Technical Note

To: Christopher Crowley, James Gavin, Joel Casstles, Lewis Wilkes, Matthew Robert
From: Robert Hutchison
CC: Nicole Cook
Date: 29 September 2025
Re: MAG Argosy

This Technical Note (TN) outlines the ground conditions and summary of geotechnical issues relating to the above site, suitable for preliminary costing purposes.

Figure 2.1 – Summary of cut and fill works for the Argosy works.

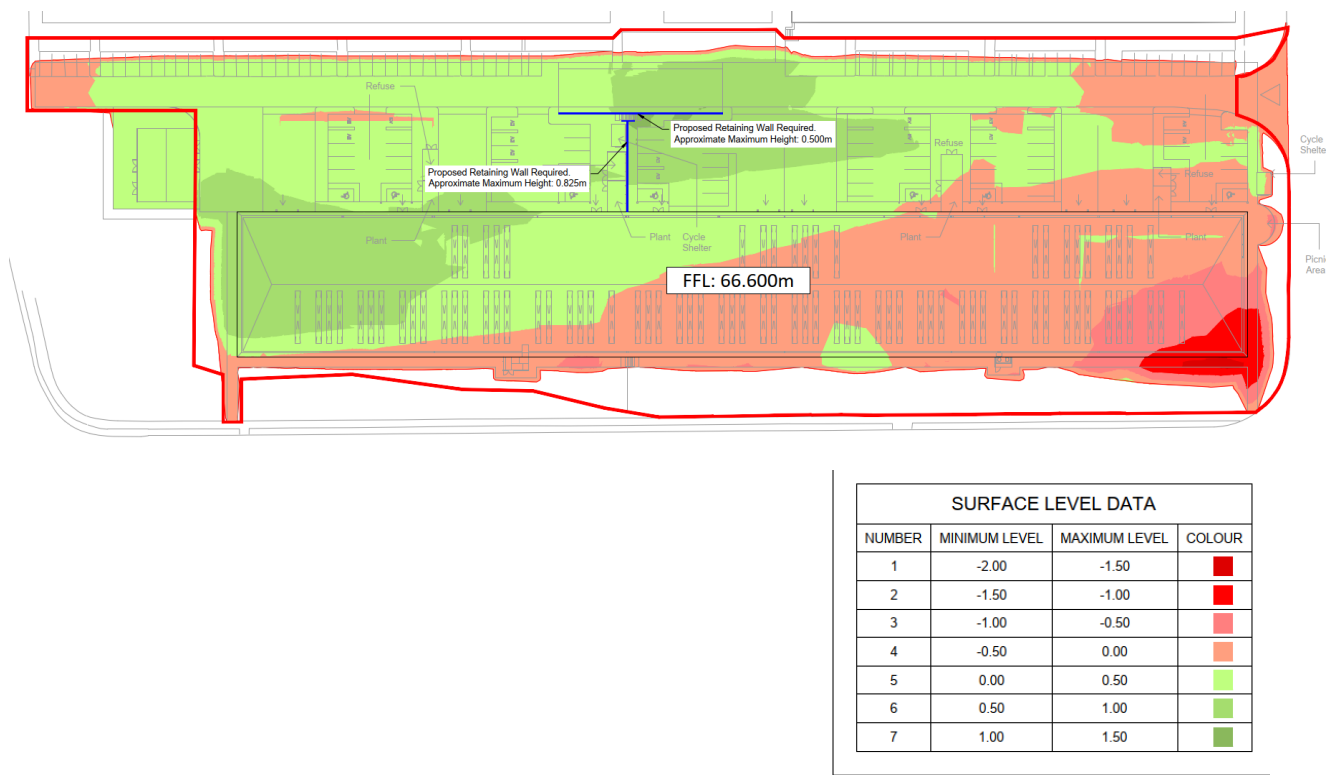
In broad terms, there is up to 0.5m of fill, coupled with a general cut of 0.5m. Localised the cut and fill does increase to 1m.
